# Program Bulletin

**SB-10056449-7626**

**SUBJECT:** Incorrect Front Fascia Grillettes

**MODELS:** 2014 Cadillac CTS  
Equipped with Twin Turbo Engine (LF3)

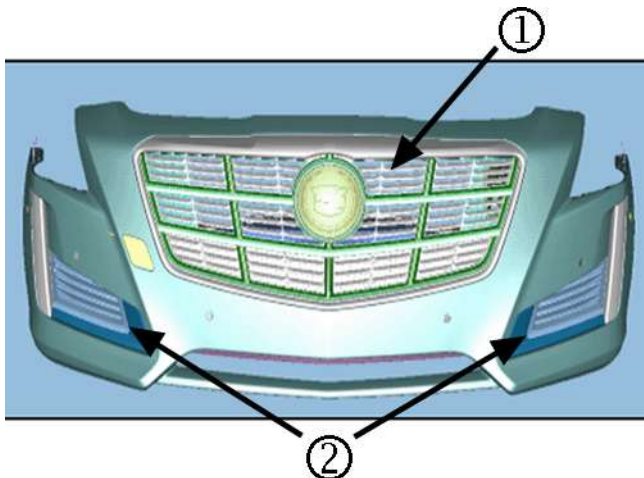
**Note:** For vehicles with bright chrome grille kits, replace the upper grille (1) and front outer grilles and bezels (2) with the black chrome service parts noted above. For vehicles with black chrome grille kits, replace **ONLY** the front outer grilles and bezels (2) with the service parts noted above.

1. Remove the front upper grille and/or front outer grilles, as necessary. Refer to *Front Grille Kit Installation* in SI.
2. Install the new front upper grille and/or front outer grilles, as necessary. Refer to *Front Grille Kit Installation* in SI.
